Service Bulletin

Replacement of tailplane mount rivets with bolts.

GA8 all serial numbers up to and including GA8-01-007.

Document: Service Bulletin SB-GA8-2001-01

Figure 1

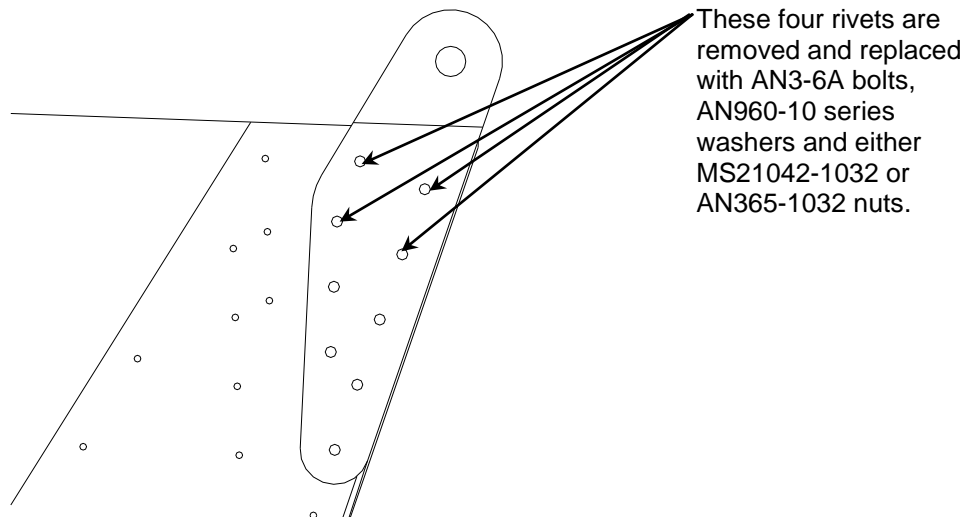
Service experience has shown the rivets which attach the rear tailplane attach brackets to the fuselage may work and fail.

1. For aircraft with less than 200 hours total time in service the rivets attaching the rear tailplane attach bracket to the fuselage must be inspected, both inside and outside, before next flight. As part of this inspection the tailplane should be pushed at the tip in a fore and aft direction while a second person inspects the fittings for relative movements.

If any sign of working rivets are found action 2 must be completed before next flight. If no sign of working rivets is found action 2 must be completed at the next 100 hourly inspection.

2. Aircraft with more than 200 hours time in service and those required to comply with this action under action 1 must be modified by removing the top four rivets, drilling the holes out to 3/16" \varnothing and installing four AN3-6A bolts with AN960-10 series washers and either MS21042-1032 or AN365-1032 nuts. Ensure the correct thread engagement is achieved by the use of AN960-10 and AN960-10L washers as necessary.

3. Following modification in accordance with action 2 the attachment of the fitting to the fuselage must be inspected at every 100 hourly inspection for any signs of looseness, relaxing of the bolts, further working rivets or general damage. Any defects must be reported to Gippsland Aeronautics before further operation.
